## **PLAN REVIEW SHEET**

Petition:

2017-110

Lincoln Harris, LLC

Below is an image of the standard detail (60.01B) for the requested bus stop pad. Permanent easement is requested, where dimensions exceed existing or proposed right-of-way limits.

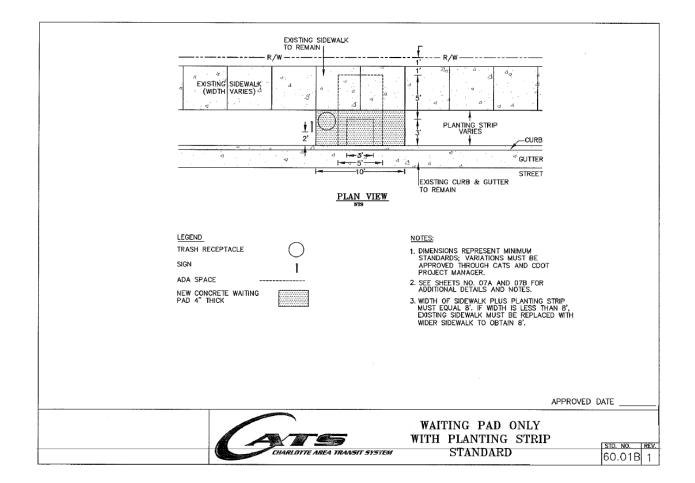
This site is located on a new planned bus route along Fairview Road. The Petitioner is requested to provide and construct a new waiting pad for a new bus stop on Fairview Road along this site's frontage.
